SITE/SI EVALUATION FOR ON-SI WASTEWATER

Changes for # 01-5-3047 Jannie Wimberly
 Changes were made to get house out of Septic Area
 by gutter as

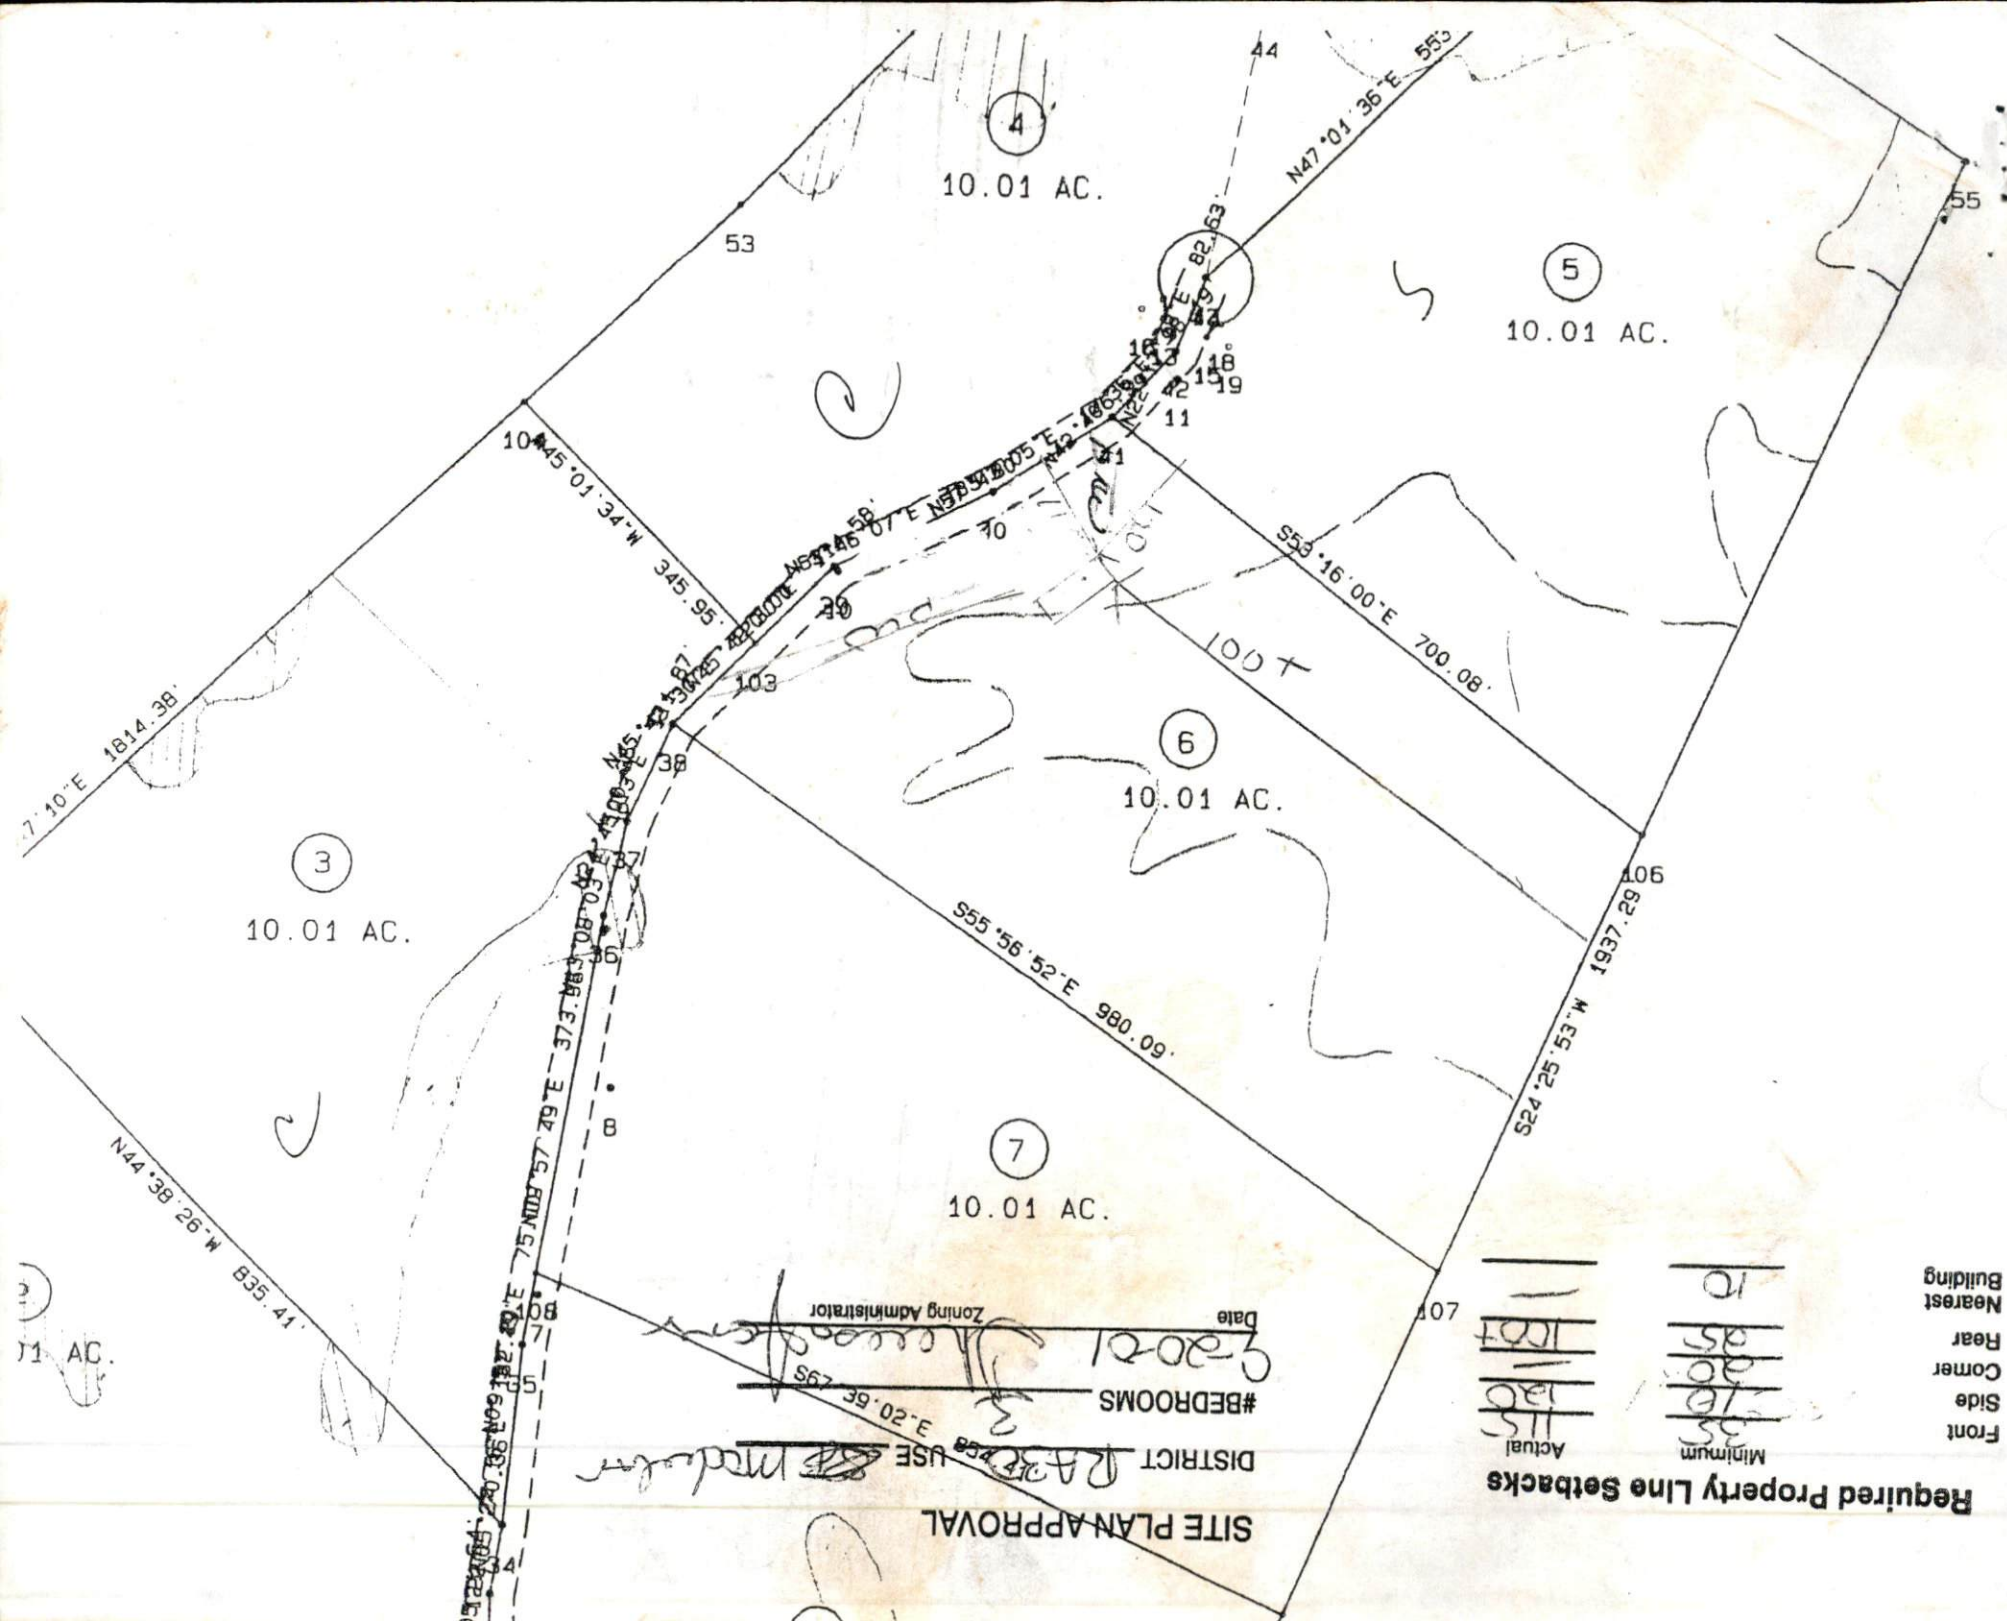
Must
on site
may not require
Pump

5x100
18"
MAX
